Zancor Homes
Wasaga Townhomes

APPLICANT'S COPY

model
TH-3

FRONT ELEVATION 'B'

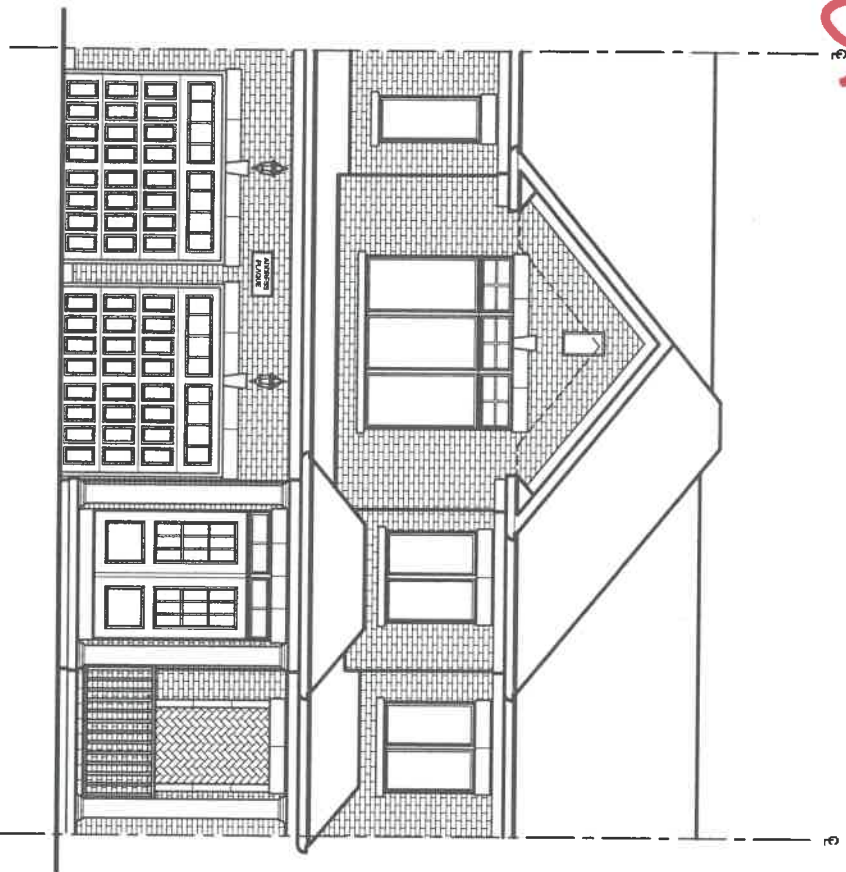
125-2
125-4
Elev B
LOB.

PARTIAL GROUND FLOOR ELEV 'B'

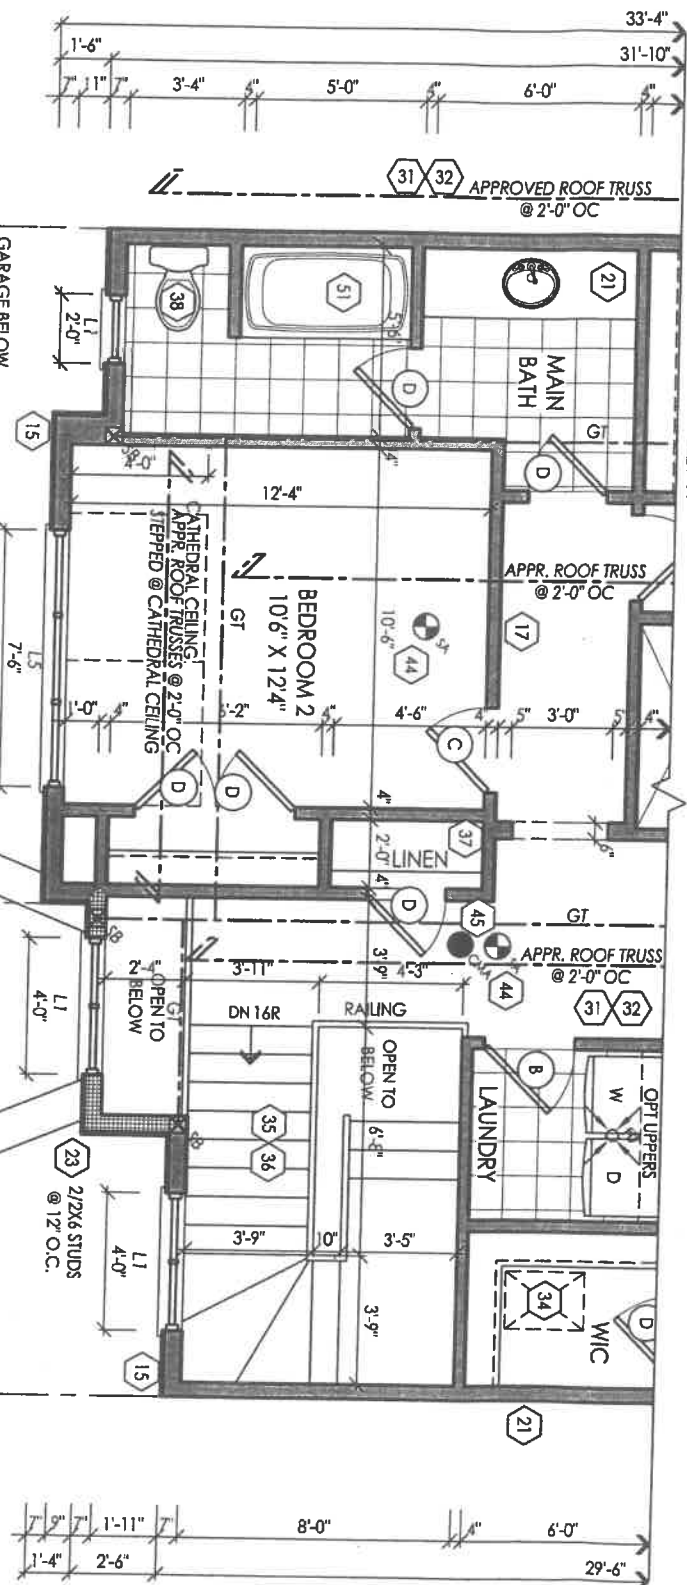
↑
over
— shift

BASEMENT FLOOR ELEV. 'A' & 'B'

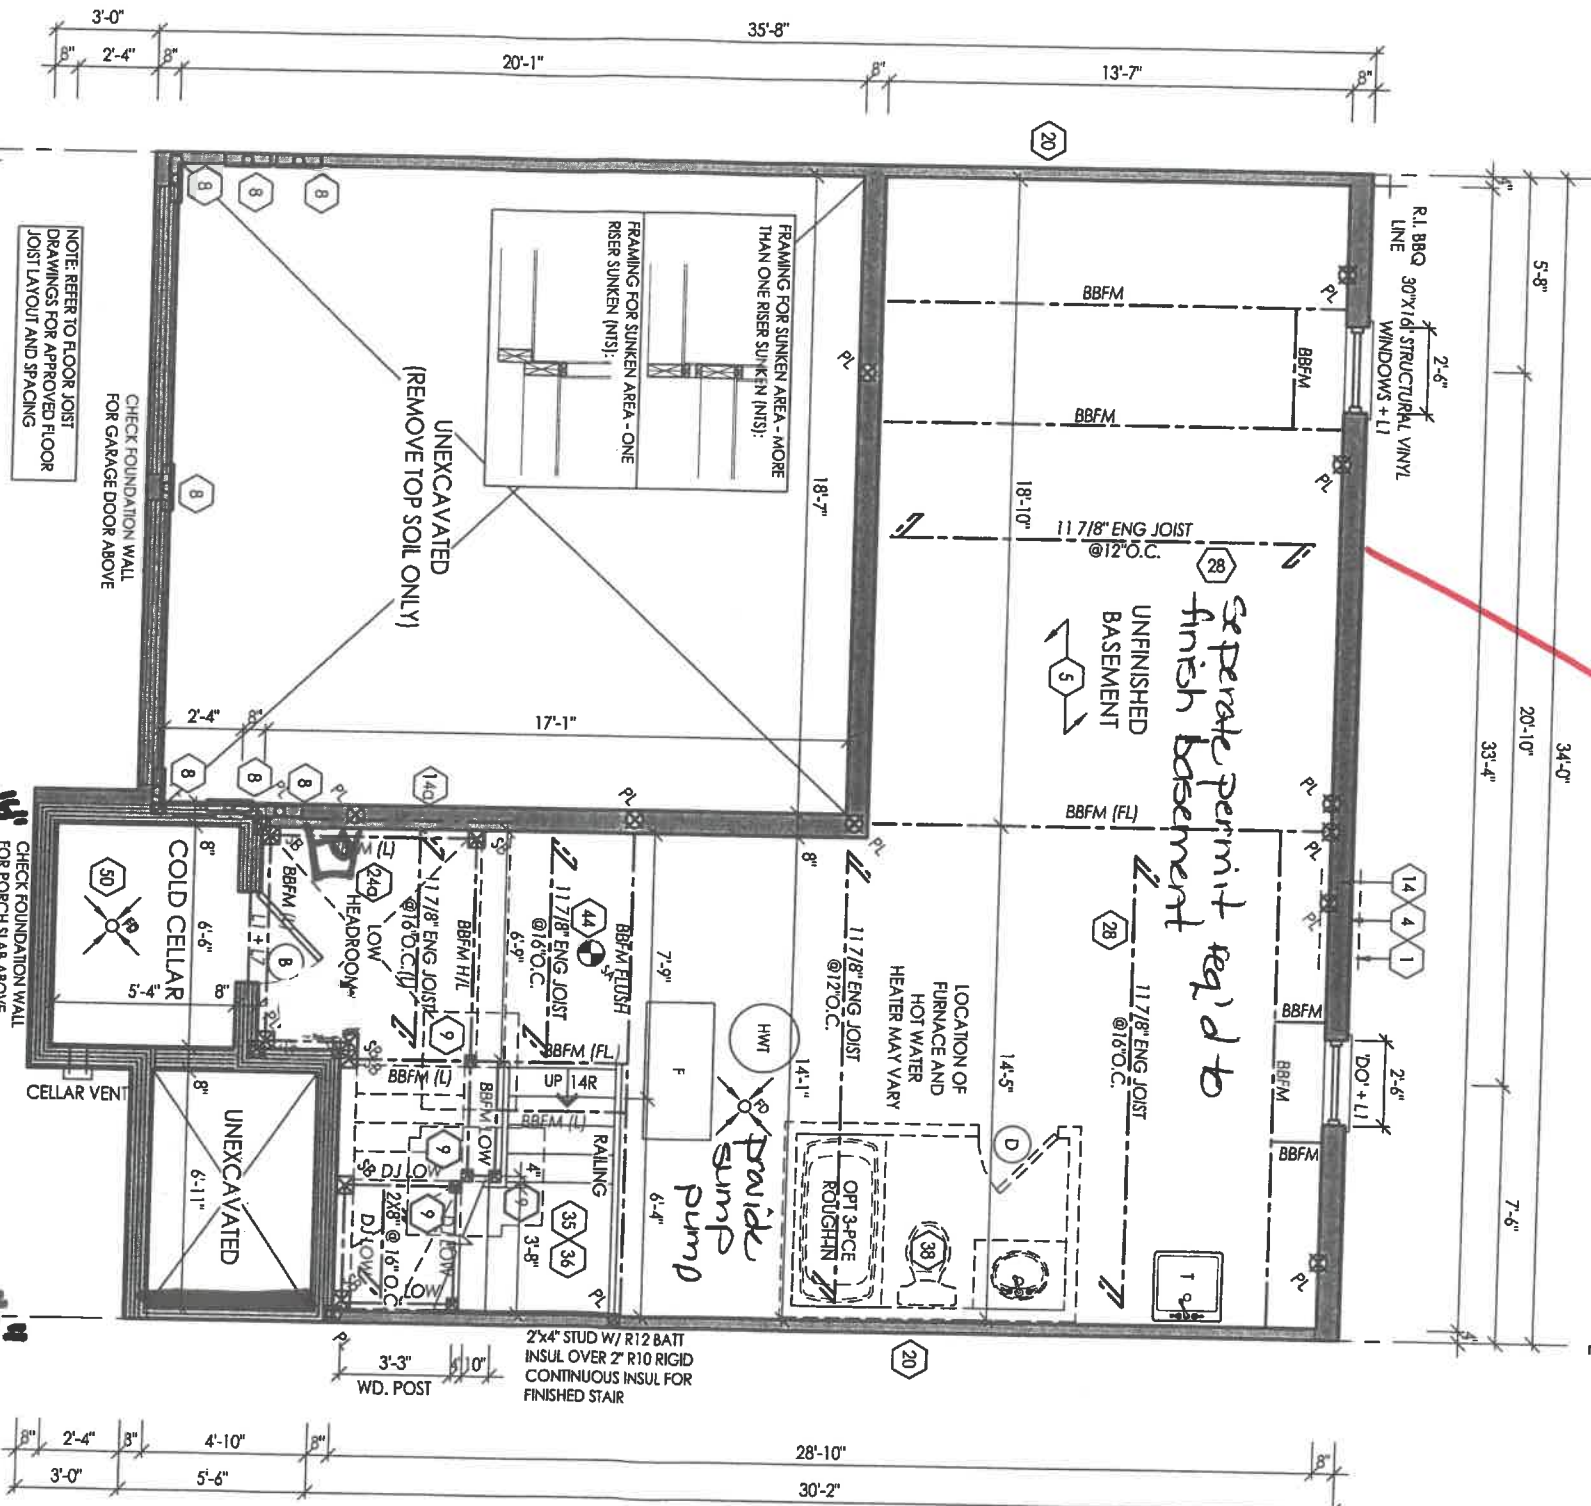
see out condition

* waterline to be 3/4" from main to farthest bathroom group

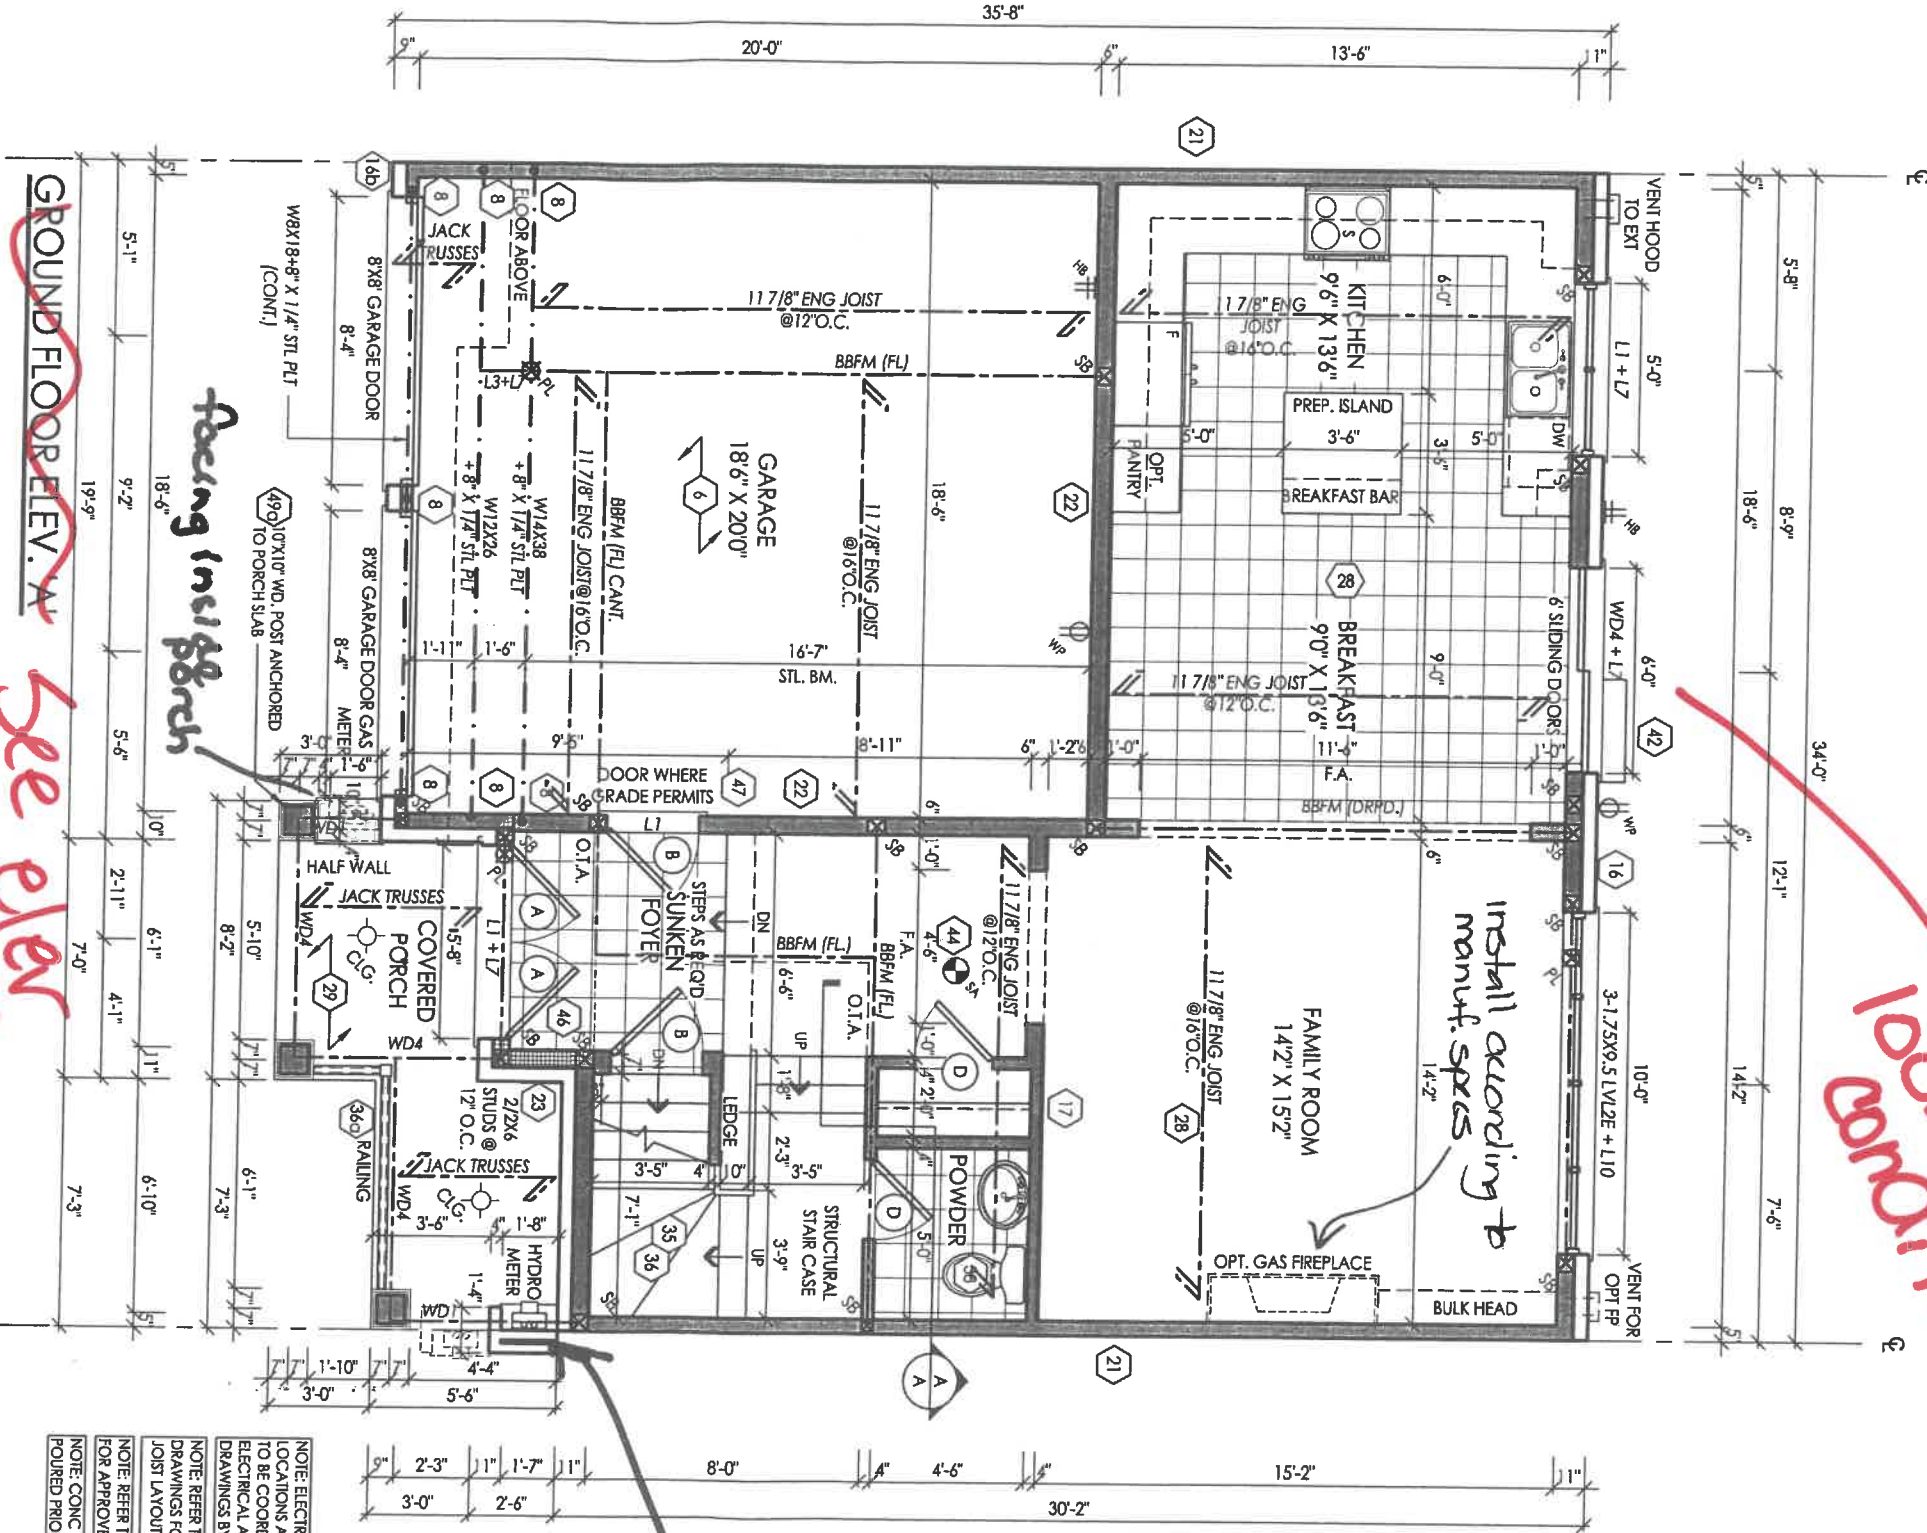
See your floor plan for location

shift door 1'
